Proposal for amendments to ECE/TRANS/WP.29/GRVA/2024/12

Note: The text reproduced below is based on the document ECE/TRANS/WP.29/GRVA/2024/12 and GRVA-18-14. This is a consolidation of the amendments with modifications to the existing text of the Regulation indicated in bold for new characters and strikethrough for deleted characters and those that are related to GRVA-18-14 are shown in red text.

Insert new paragraphs 6.4. to 6.5.1., to read:

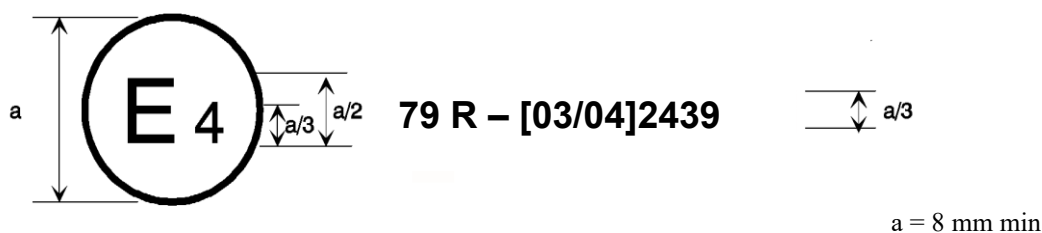
- “6.4. Vehicle is equipped with ACSF which has been exempted from the requirements of this UN Regulation: yes/no**
- 6.4.1. If yes, details:**
- 6.5. Vehicle is equipped with a steering system which exhibits functionality defined as an ACSF of Category ~~B2, D or E~~: yes/no**
- 6.5.1. If yes, details:”**

Model A

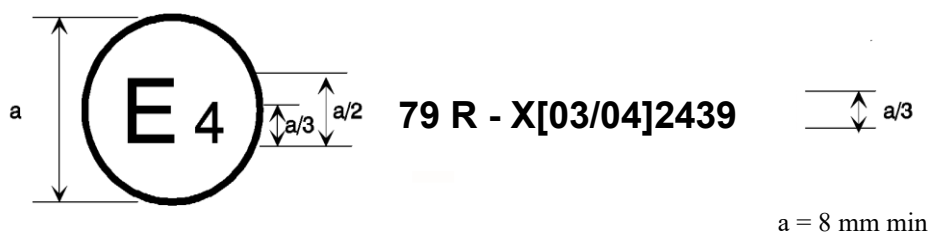
Annex 2, amend to read with square brackets amended as appropriate :

The above approval mark affixed to a vehicle shows that the vehicle type concerned has, with regard to steering equipment, been approved in the Netherlands (E 4) pursuant to UN Regulation No. 79 under approval No. [03/04]2439. The letter “X” preceding the approval number indicates that the vehicle is equipped with ACSF which has been exempted from the requirements of this UN Regulation, and/or that the vehicle is equipped with a steering system which exhibits functionality defined as an ACSF of Category ~~B2, D or E~~. The approval number indicates that the approval was granted in accordance with the requirements of UN Regulation No. 79 incorporating the [03/04] series of amendments.”

Model B

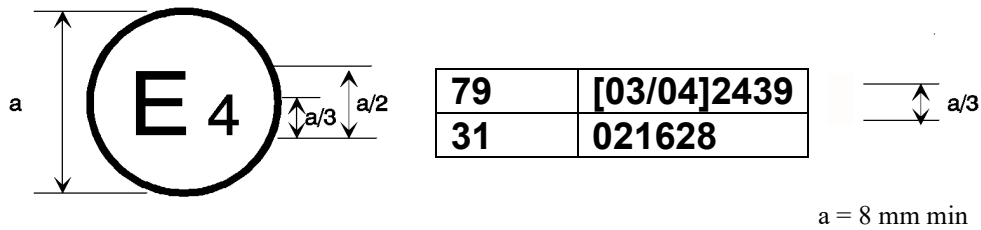
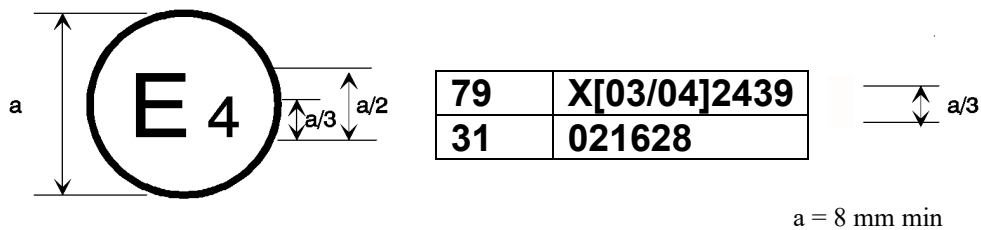
The above approval mark affixed to a vehicle shows that the vehicle type concerned has been approved in the Netherlands (E 4) pursuant to Regulations Nos. 79 and 31.^d The letter “X” preceding the approval number pursuant to Regulation No. 79 indicates that the vehicle is equipped with ACSF which have been exempted from the requirements of this UN Regulation, or that the vehicle is equipped with a steering system which exhibits functionality defined as an ACSF of Category **B2, D or E**. The approval numbers indicate that, at the dates when the respective approvals were given, UN Regulation No. 79 incorporating the [03/04] series of amendments and UN Regulation No. 31 included the 02 series of amendments.”
